UNITED STATES
NUCLEAR REGULATORY COMMISSION
WASHINGTON, D.C. 20555-0001

SAFETY EVALUATION OF THE PROPOSED REPAIR
FOR THE VERMONT YANKEE CORE SHROUD
VERMONT YANKEE ATOMIC POWER CORPORATION
DOCKET NO. 50-271

VERMONT YANKEE - SHROUD WELDS
FIGURE 1

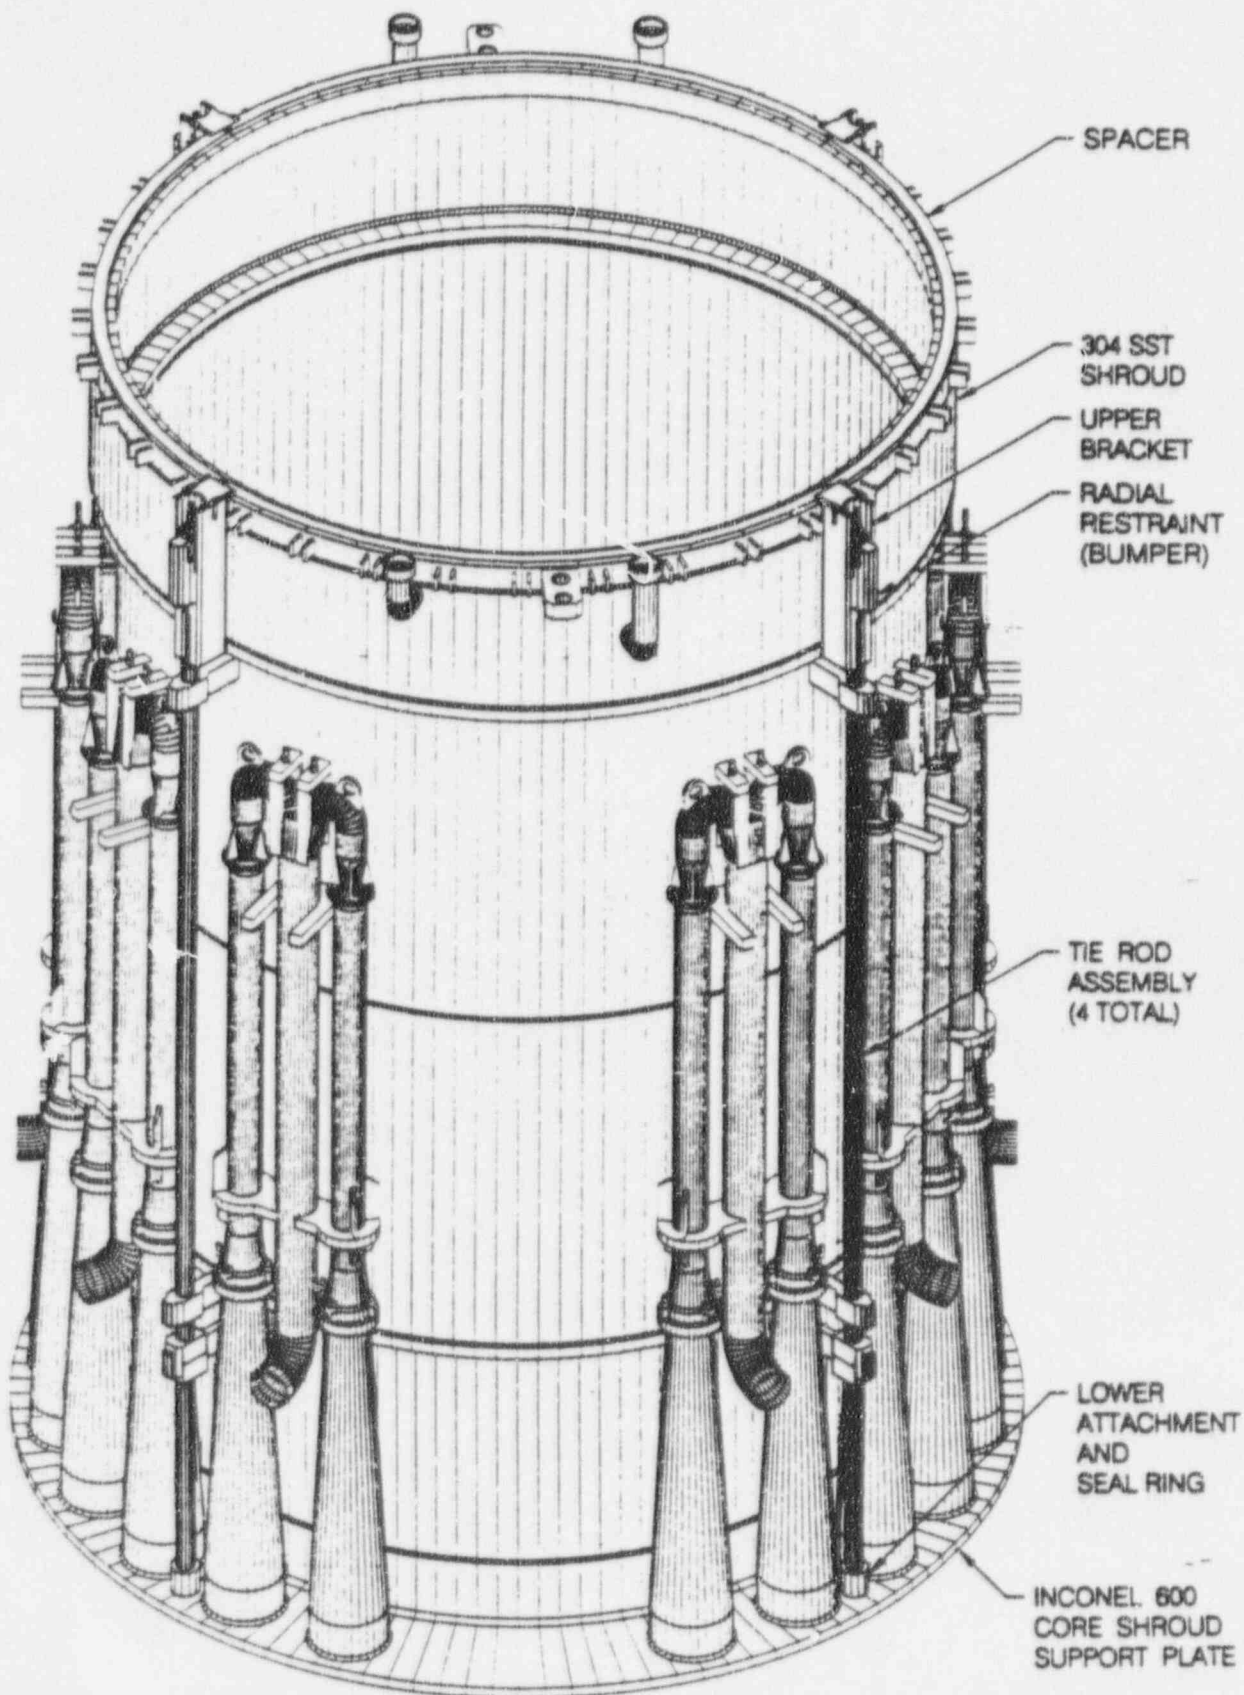
The VY core shroud repair is designed to replace all potentially-sensitized 304 stainless steel circumferential core shroud welds, i.e., H1 through H7 (See Figure 1). In addition, the modification can accommodate a complete failure of the H8 shroud weld considering the shroud support legs remain intact. The design life of the modification is 40 years.

A range of potential single weld and multiple weld failures were considered. The single weld failures analyzed included the failure of H7, H4 and H3. The H7 weld is the lowest-elevation circumferential weld and has the largest mass above it. In addition, breaks below the core support plate result in both lateral core supports (top guide and core support plate) being above the break. Analyses of the structure were also conducted in the horizontal and vertical directions to demonstrate that the installation of the repair hardware has no impact on the response of an intact shroud.

Prior to installation of the shroud repair, VY will perform ultrasonic inspections of design reliant welds -- circumferential welds which provide an alternate path for the loads carried by the vertical welds. These inspections will cover portions of the vertical welds in the H3/H4, H4/H5 and H6/H7 shroud segments, the welds in the core support ring and welds H8 and H9.

The repair relies on portions of the vertical welds in the H1/H2 shroud segment to be intact. However, due to tooling limitations, it is not practical to ultrasonically inspect the vertical welds in the H1/H2 shroud segment. Therefore, rather than inspect these vertical welds, portions of circumferential welds H1 and H2 are designated as design reliant welds. Welds H1 and H2 were ultrasonically inspected in 1995. The results of these inspections will be used to demonstrate that sufficient design-reliant weld length exists. VY is considering H1 and H2 as design-reliant welds only for inspection reasons; the repair is designed as a repair to H1 and H2.

VERMONT YANKEE - SHROUD REPAIR
FIGURE 3

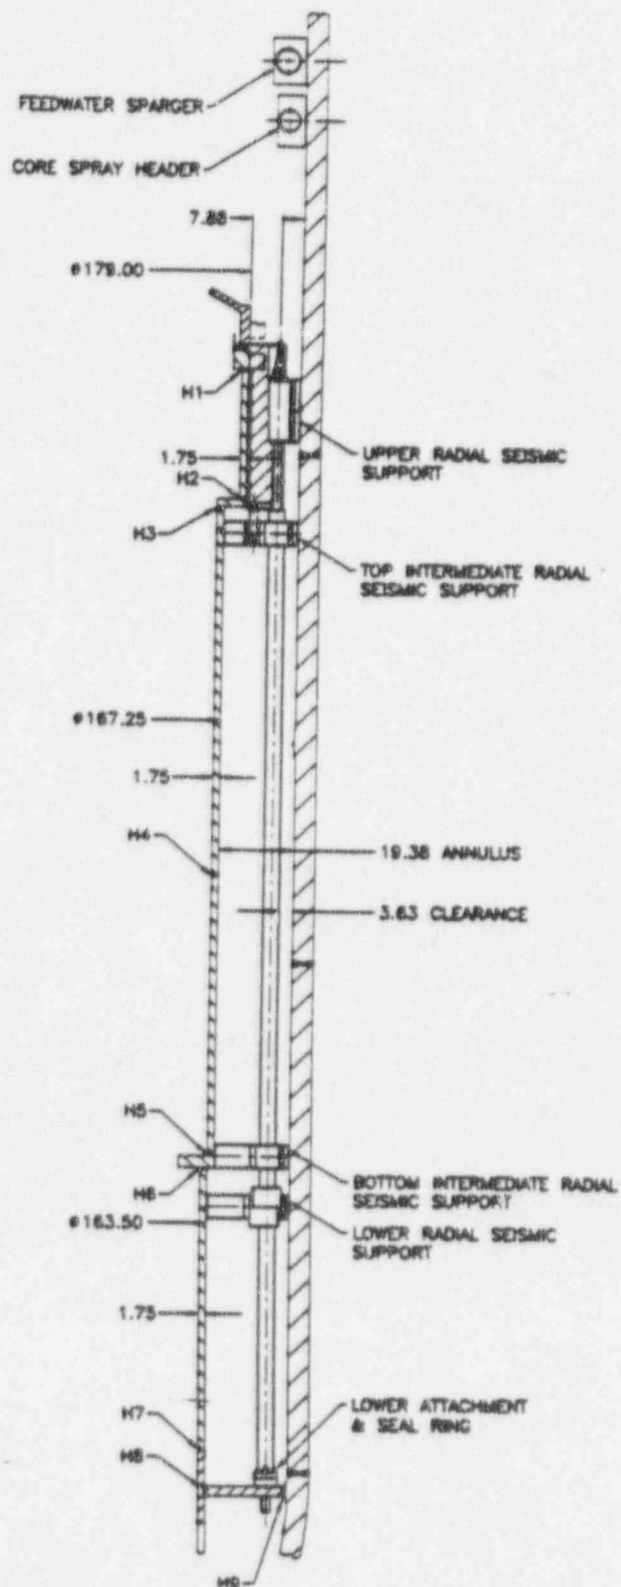
The core shroud modification design consists of four tie rod assemblies installed 90° apart in the core shroud/reactor vessel annulus. Each assembly consists of a tie rod, upper bracket, lower T-head and seal assembly, and four lateral restraints (see Figures 2 and 3). The assemblies, which are designed and fabricated as safety-related components, are used to maintain the alignment of the core shroud assuming all circumferential welds are cracked 360° throughwall.

A spacer ring is provided between the top shroud flange and shroud head. Cutouts are provided in the ring which allow the top bracket to be hung from the top shroud flange. The bracket is captured by the shroud head and the top lateral restraint. The bracket extends from the top flange to just above the H3 weld and provides support for the top lateral restraint. The tie rod passes through a hole in the top lateral restraint and bracket and is held by a nut. The tie rod extends down to the T-head at the shroud support plate.

The T-head is connected to the plate through a hole which is machined in the shroud support plate. The hole in the shroud support plate is sealed with a seal ring which is preloaded against the support plate. The seal preload is independent of the preload in the tie rod.

The radial restraints are solid stainless steel spacers which provide positive rather than spring-type lateral restraint of the core shroud. The restraints are integral with the tie rod assemblies. The restraints are installed based on field measurements to provide a small effective gap relative to the vessel wall. At the shroud elevations which support the top guide and core support plate, the effective gap is about 1/8-inch. At the upper intermediate and bottom radial restraint locations, a slightly larger effective gap of 1/2-inch is provided. As discussed later in this Safety Evaluation (SE), these gaps result in acceptable shroud displacements during all loading conditions.
